IOWA DEPARTMENT OF NATURAL RESOURCES
LAND & WATERS BUREAU
WALLACE STATE OFFICE BUILDING

ADDENDUM No. 2

GYPSUM CITY OHV CAMPGROUND
SANITARY SEWER
WEBSTER COUNTY, IOWA
PROJECT NUMBER: 16-02-94-01

JUNE 21, 2016

Project No: 1140397
 Sheet D.06

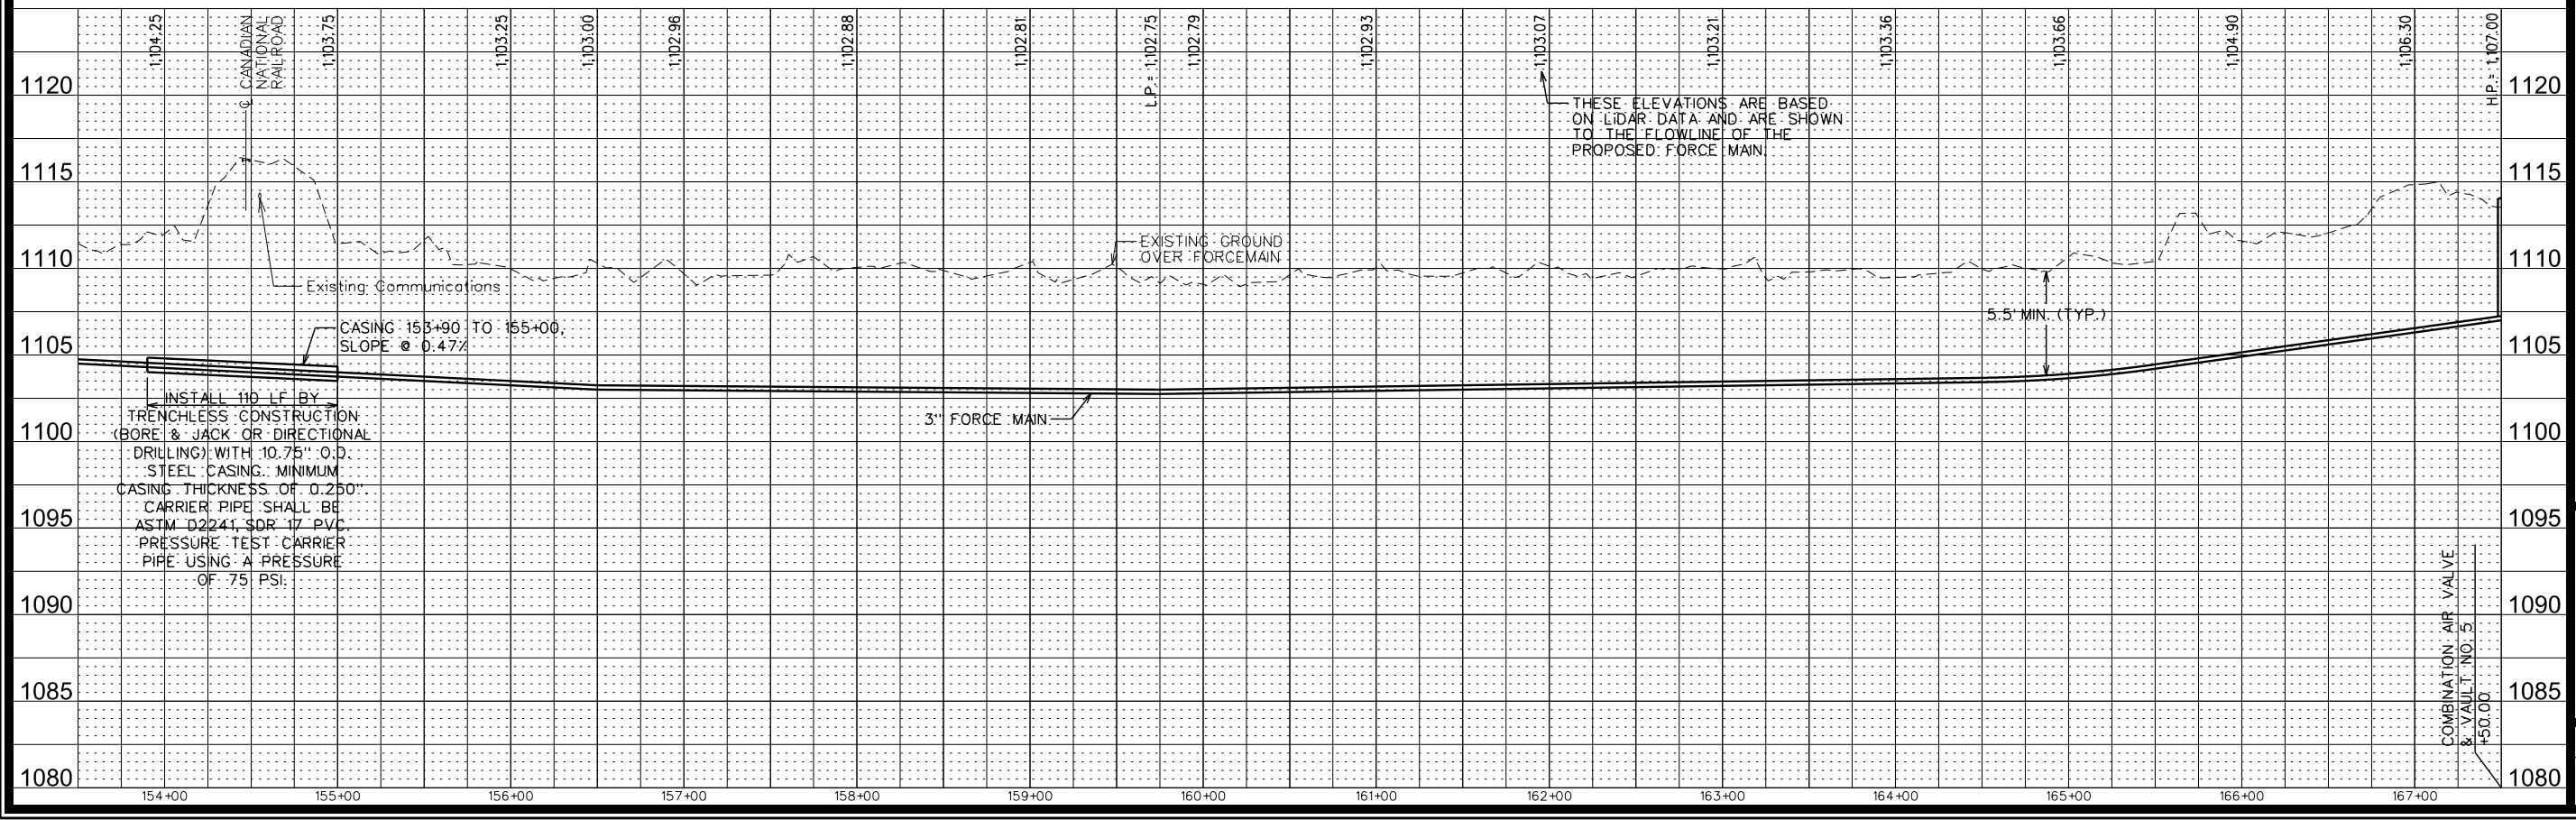
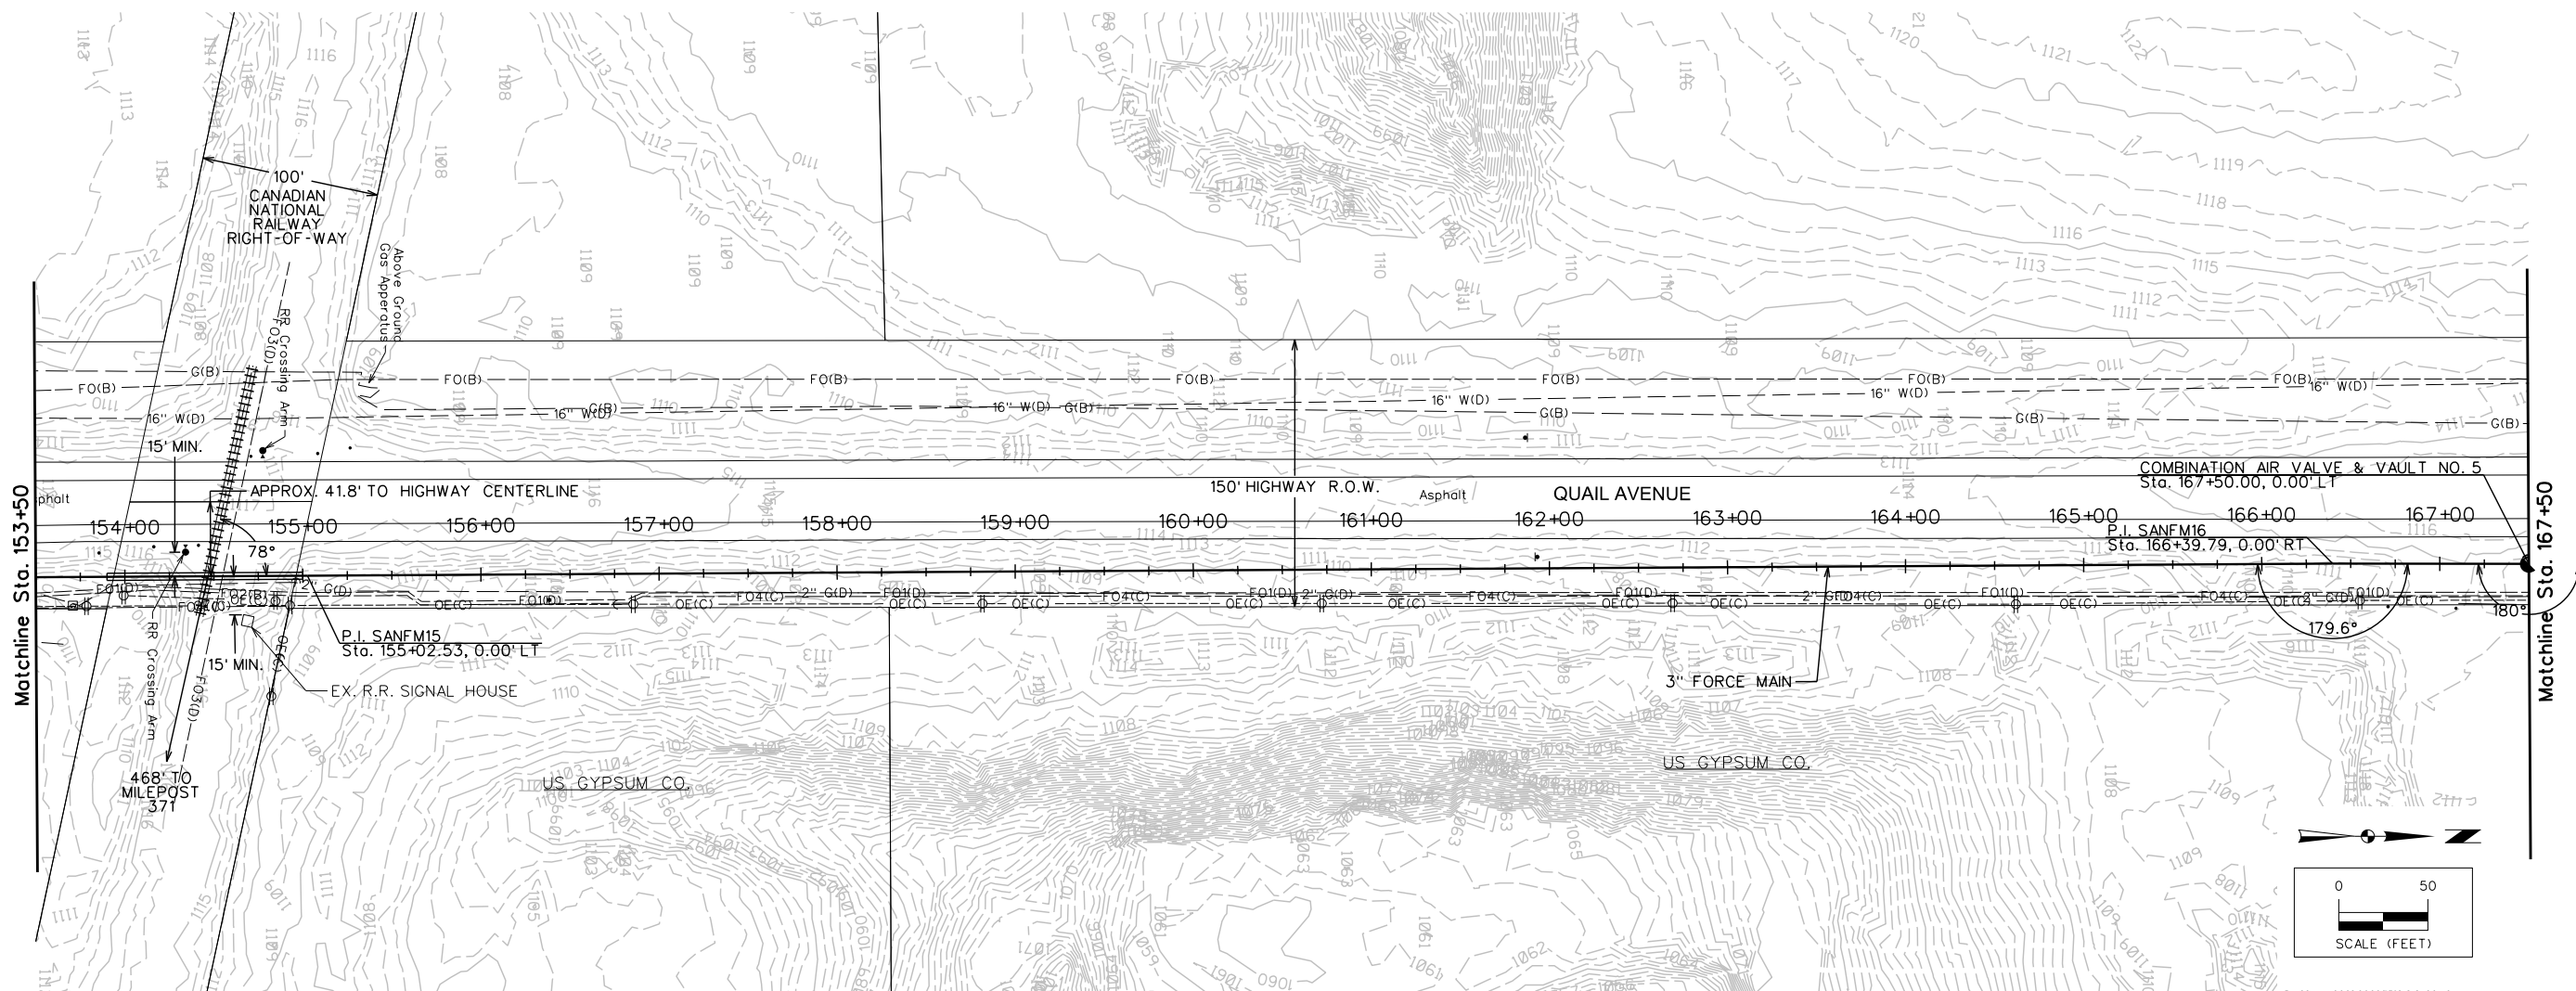
- A. G.03 - Base Bid Estimated Project Quantities: Base Bid Item No. 5 - Sanitary Sewer Force Main Trenchless PVC 3-Inch, the estimated quantity shall be 14,262 LF.
- B. D.06 - Sanitary Force Main Plan & Profile: The force main railroad crossing shall maintain a minimum distance of 15 feet from both the railroad crossing arm and railroad signal house per Canadian National Railroad requirements. See attached plan sheet D.06.
- C. C.01 - Detail 4 - Typical Sewer Combination Air Valve and Vault:
 - a. Note 1 - Add the following: Air valve approved equal: 2" A.R.I. D025 fiberglass-reinforced nylon valve.
 - b. Replace Note 2 with the following: Use MJ Tee with MJ adaptors if combination air valve is manufactured by Val-Matic.
 - c. Add Note 3: Air valve shall be rigidly restrained with stainless steel wall brace secured to manhole wall if combination air valve is manufactured by Val-Matic.

INSTALL 10' LF BY
 TRENCHLESS CONSTRUCTION
 (BORE & JACK OR DIRECTIONAL
 DRILLING) WITH 10.75" O.D.
 STEEL CASING. MINIMUM
 CASING THICKNESS OF 0.250".
 CARRIER PIPE SHALL BE
 ASTM D2241, SDR 17 PVC.
 PRESSURE TEST CARRIER
 PIPE USING A PRESSURE
 OF 75 PSI.
